CITY OF CONCORD
New Hampshire's Main Street™
Community Development Department
Planning Division

Staff Report for Planning Board

Project Summary –Major Site Plan and Architectural Design Review

Project: Key Auto Group Hotel – Major Site Plan (2026-005)
Property Owner: 94 Manchester Street, LLC
Applicant: TFMoran, Inc
Property Address: 94-98 Manchester St
Tax Map Lot: 781Z 12, 781Z 12-1, 781Z 12-2, and 781Z 12-3

1-sheet ROW map for CIP 36, dated February 18, 2021 prepared by Hoyle, Tanner & Associates, Inc in black with the proposed hotel site layout plan dated January 21, 2026, prepared by TFMoran in red.

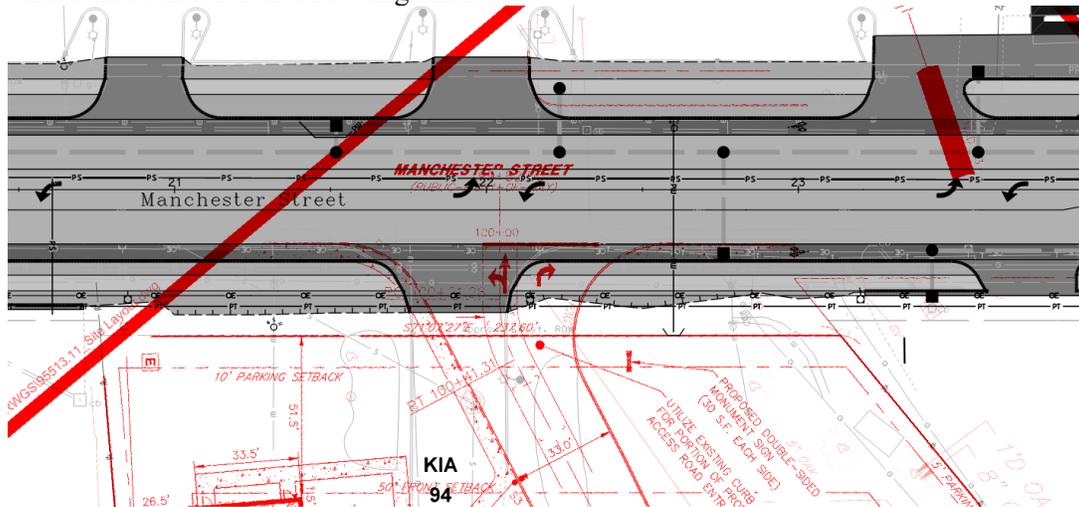
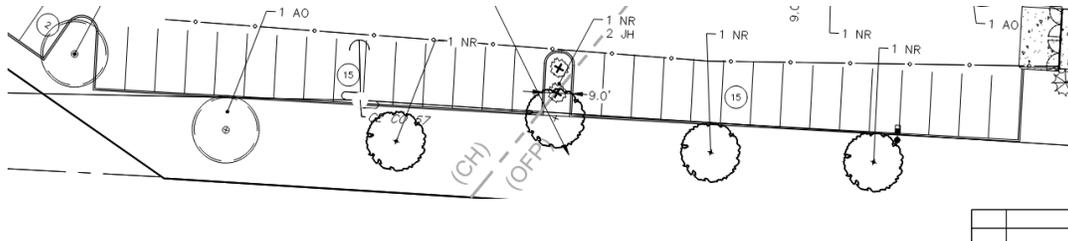
3.38 Section 19.11 *Alignment* requires individual driveways and access ways to public streets or common private drives shall be laid out so as to intersect as nearly as possible at right angles.

Specifically, the reconfigured driveway no longer intersects with the public right-of-way at a right angle. This configuration will further be worsened with the alignment with the CIP 36 Manchester Street project, currently budgeted for construction in FY 28. The applicant shall redesign the proposed driveway to accommodate a right-angle intersection with both the existing and future Manchester Street alignments.
